Re: Encino Park

Reference is made to the Preliminary Overall Area Development Plan (POADP) for Encino Park (File #83-17-65-86) submitted for staff review and comment. The conceptual plan was jointly reviewed by Traffic Engineering and Planning staff. Specifically, the review was directed at areas for which plats have not been approved or recorded.

# encino park master plan

## preliminary overall area development plan

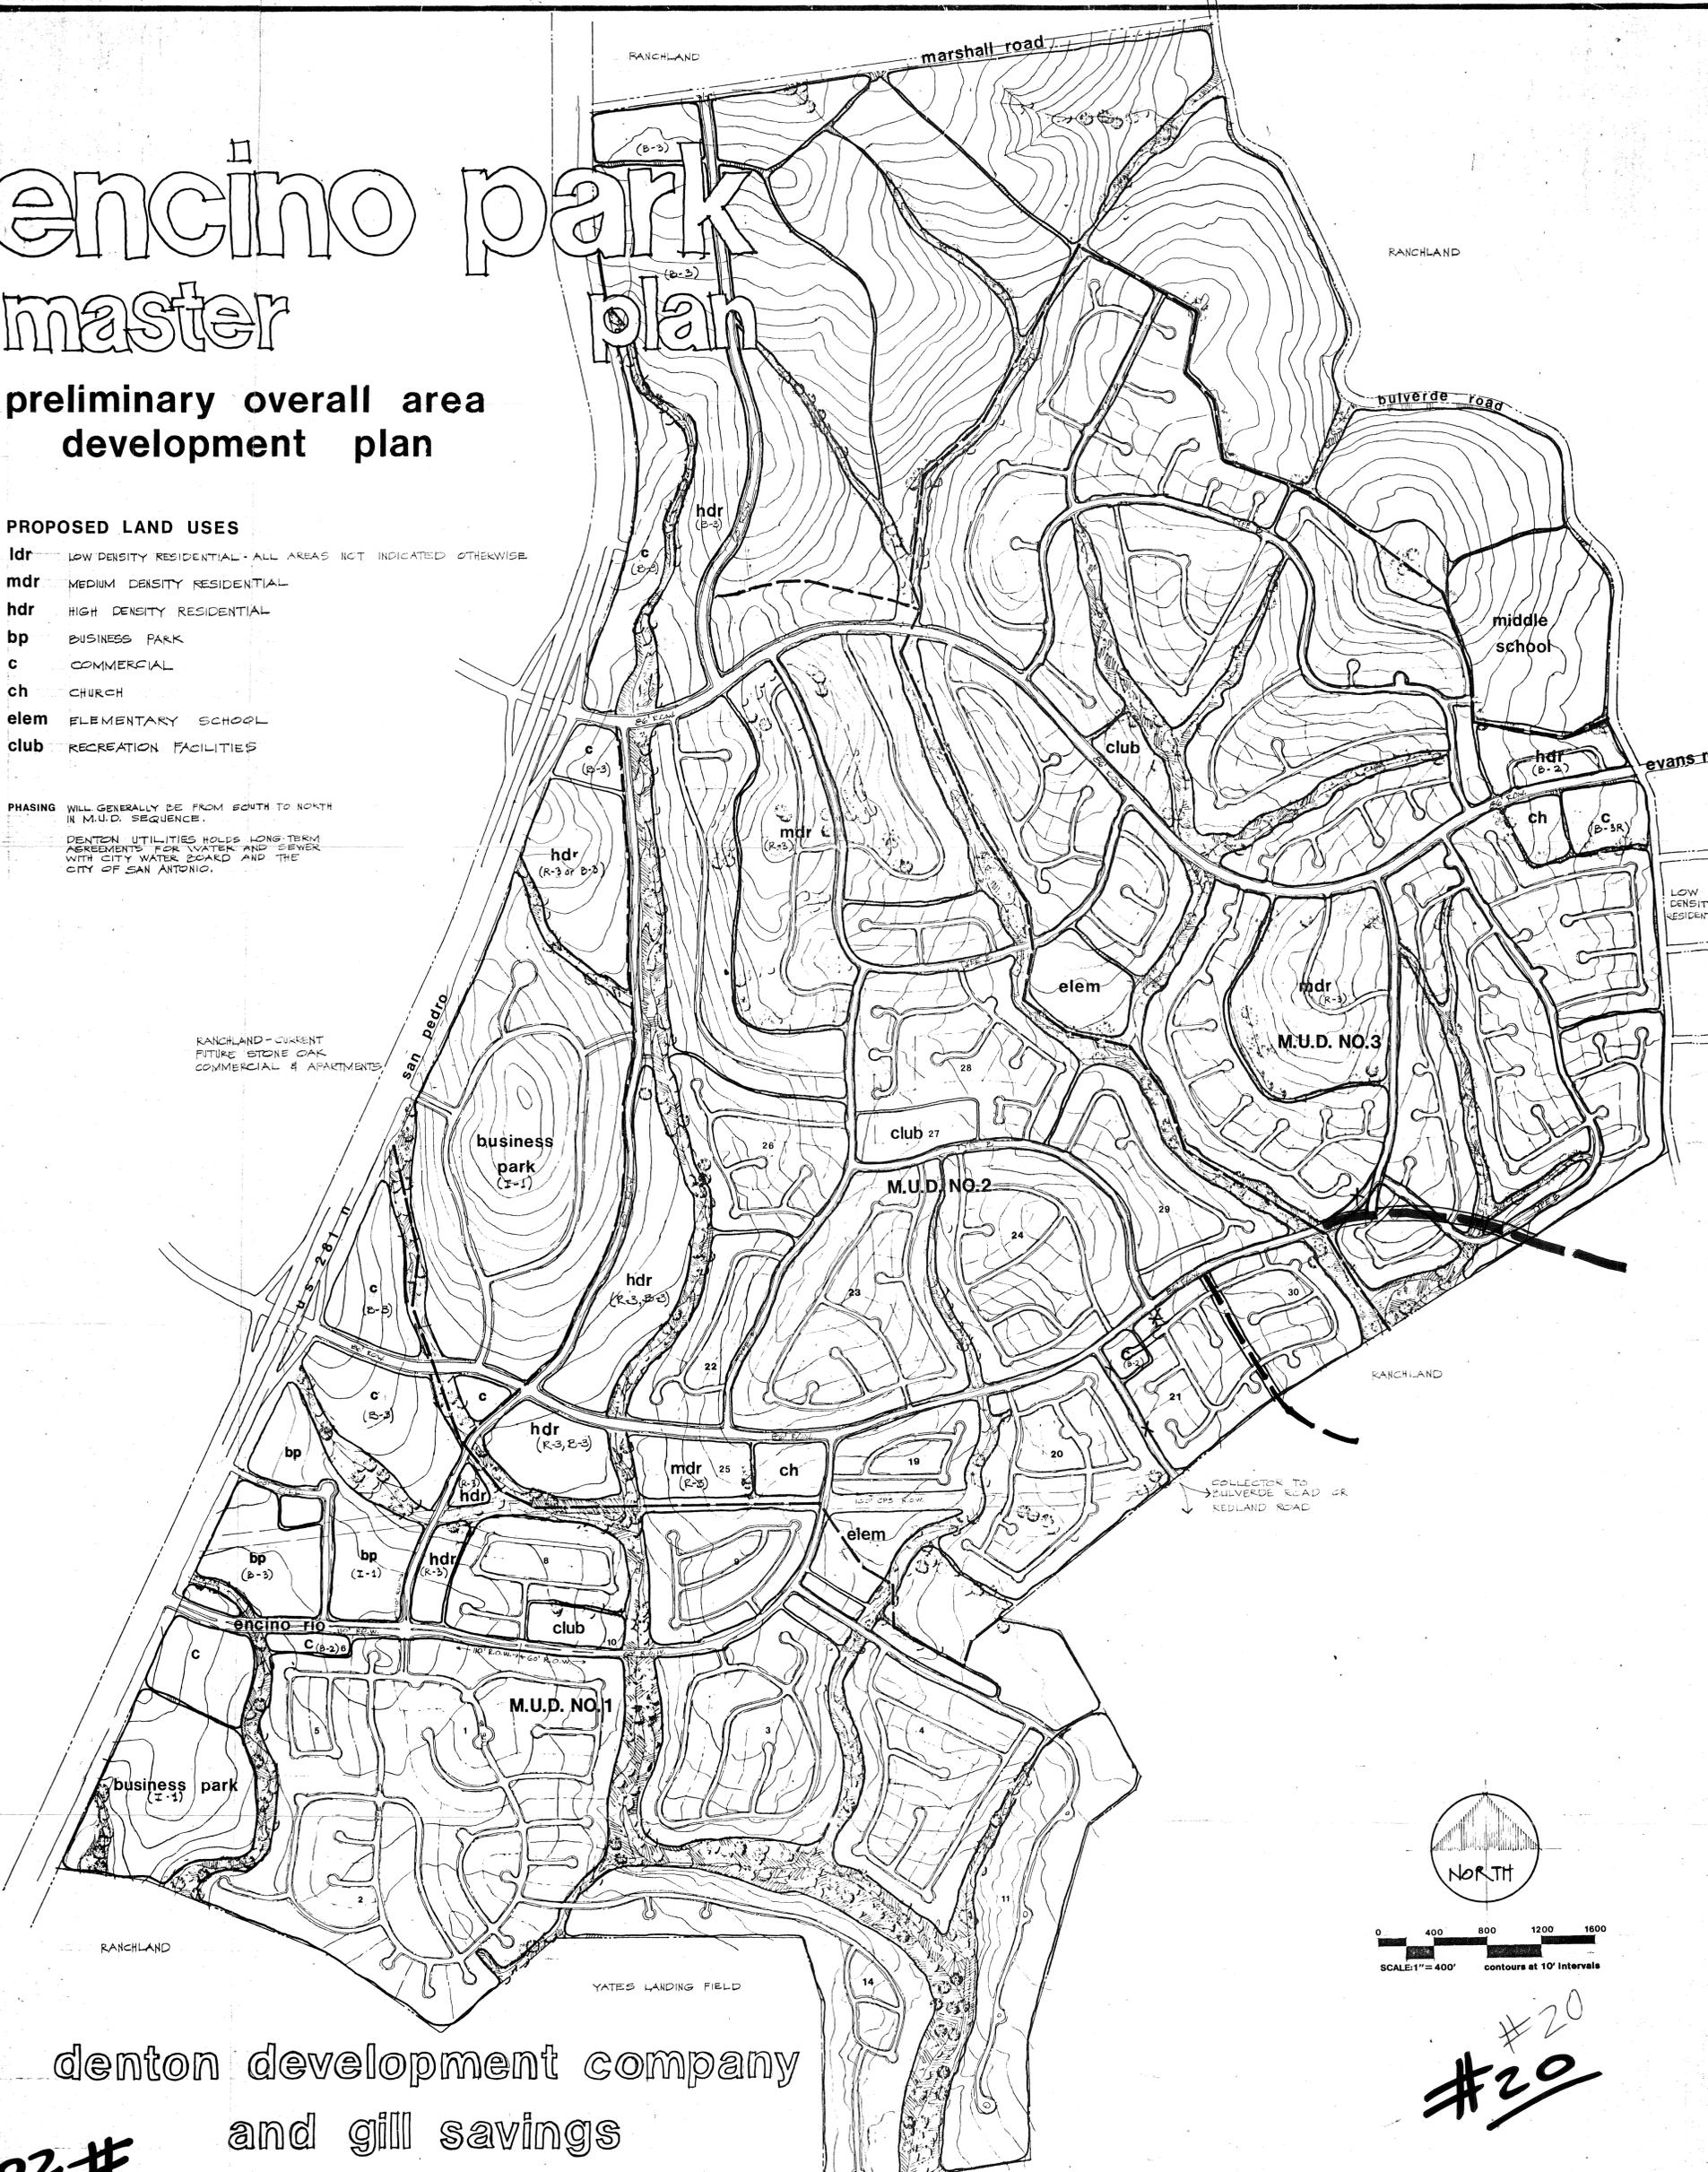
Analysis of the overall plan concludes that the planned proposal is in general compliance with Chapter 36. However, please note that this department is currently studying the future need for a major thoroughfare in this rapidly growing area. A study of this area is indicative of the need to classify Evans Road and Bulverde Road as arterials streets. The tentative plan calls for designating Evans Road as a secondary arterial type "A" street (86' R.O.W.), and Bulverde Road as a primary arterial type "A" (110' R.O.W.) south of Evans and as a secondary (86' R.O.W.) north of Evans. Given the proposed addendum to the Major Thoroughfare Plan, it is recommended that you plan the collector street linking Evans Road and U.S. 281 North (San Pedro Avenue) as an 86' facility. Staff's recommended proposal would then be consistent with the planned major thoroughfare amendment.

Additionally, we are aware of a planned primary arterial (110' R.O.W.) thru Stone Oak Subdivision on the west side of U.S. 281 North. The proposed 110' facility on the Stone Oak plan appears to be in general alignment with your planned "Evans Road extension" street. In view of this, we recommend that the "Evans Road Extension" be 110' R.O.W. from U.S. 281 east to the first collector street (a distance of approximately 700') and then transition to 86' R.O.W. Further, it is recommended that the balance of Encino Rio which will be platted in conjunction with future units, be upgraded to an 86' facility up to the Evans Road extension. Regarding Bulverde Road, if areas contiguous to said road are expected to be platted in the near future, before consideration of the proposed Major Thoroughfare Plan by the Planning Commission and City Council, we ask that serious attention be given to provide dedication for street widening in order to accommodate the projected thoroughfare. If additional information relative to the proposed Major Thoroughfare is needed, please make contact with Mr. Al Eisenwenger of our Transportation Study Office.

*Need dimensions for all proposed collectors, secondaries & arterials streets*

( ) See annotations/comments on attached copy of your plan.
(X) Comments: This is to acknowledge receipt of the revised POADP dated Jan. 20, 1984 reflecting a street between Units 21 & 30. Said street was formerly planned as a collector street and is now being upgraded to 86' facility as discussed in our meeting of January 17, 1984. In this regard, staff offers no objection to the street amendment.

reflecting a street between Units 21 & 30. Said street was formerly planned as a collection street and is now being upgraded to 36' facility as discussed in our meeting of Jan 17, 1984 as previously mentioned, staff offers no objection to the proposed street alignment.

The revised Preliminary Overall Area Development Plan (POADP) for Encino Park (File #83-10-58-22) has been reviewed by staff. Amendments to the plan involved provisions for a new 86' thoroughfare from San Pedro to the extension of Evans Road, alignment of Encino Rio which creates a "T" intersection at the above mentioned 86' facility and the relocation of the "Evans Road extension" at San Pedro Avenue in order to cause a direct alignment with the proposed 110' street planned to the west of San Pedro Avenue in the Stone Oak Development.

In this regard, staff concensus is that the changes as shown on the P.O.A.D.P. are in accordance with prior discussion with you/client and staff. Also from that discussion, it is our understanding that the subdivision design adjacent to the 60' collector indicated to connect with Bulverde Road or Redland Road is a tentative design. This is a result of a potential amendment to the Major Thoroughfare Plan. The change if endorsed by the Planning Commission and City Council would call for a design causing the 86' thoroughfare, to curve in a southeasterly direction at or about where the 60' collector is illustrated to connect with Bulverde Road. Given the possible change to the Major Thoroughfare Plan, it is recommended that the area immediately adjacent to the collector not be platted until a definite plan has been established.

Additionally, it is noted that the POADP does not reflect Evans Road as a 110' type street where it connects with San Pedro. We have mentioned this to Mr. Ghormley in our earlier comments. We make this recommendation based on our understanding that the Stone Oak development plans call for said street to be 110' from San Pedro to the west thru their development. Therefore, relative to the intersection of Evans Road and San Pedro, we recommend that you continue Evans Road as a 110' street from San Pedro east to the first or second collector street along your proposed commercial development and then transitioning down to the 86' R.O.W.
